Staff Data Requests

B. Collinwood BioEnergy, LLC, Case No. 14-2244-EL-REN

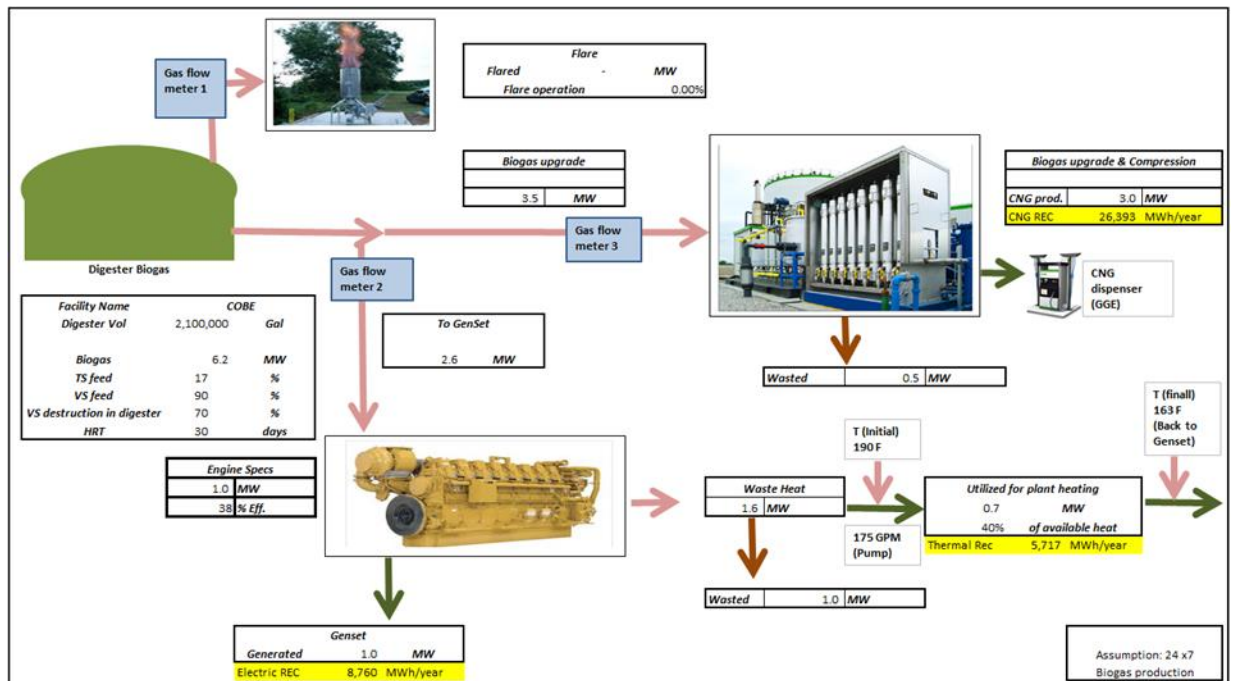
12. Regarding Section G.3 of the application, please provide a detailed description of how heat captured by each source is going to be measured and verified, including the configuration of the meter(s), the meter types(s), and meter accuracy. What is the projected in-service date of the thermal meters? Provide documentation.

Thermal REC: Engine is cooled using a heat loop which circulates Glycol-Water mixture (50%) across the plant. The flow of the glycol is **175 GPM** (Pump rating, see fig.).

We have temperature sensor located in the engine which show the temperature of glycol taking waste heat from the engine. **The temperature is typically around 190° F** (See fig. 1) This glycol flows in the plant supplying heat for plant purpose (Digester heating, Floor heating, Pasteurization). **The return temperature of glycol is around 163° F** (See fig. 1)

$$\text{Heat utilized in the plant } \frac{\text{BTU}}{\text{min}} = 1,460 \frac{\text{lbs}}{\text{min}} * (190 \text{ F} - 163 \text{ F})$$

$$\text{Heat utilized in the plant } \frac{\text{BTU}}{\text{hr}} = 2,388,499 \frac{\text{BTU}}{\text{hr}}$$

$$\text{Heat utilized in the plant MW} = 0.7 \text{ MW}$$

$$\text{Thermal REC} \left(\frac{\text{MWh}}{\text{yr}}\right) = 5,717 \text{ MWh/year}$$
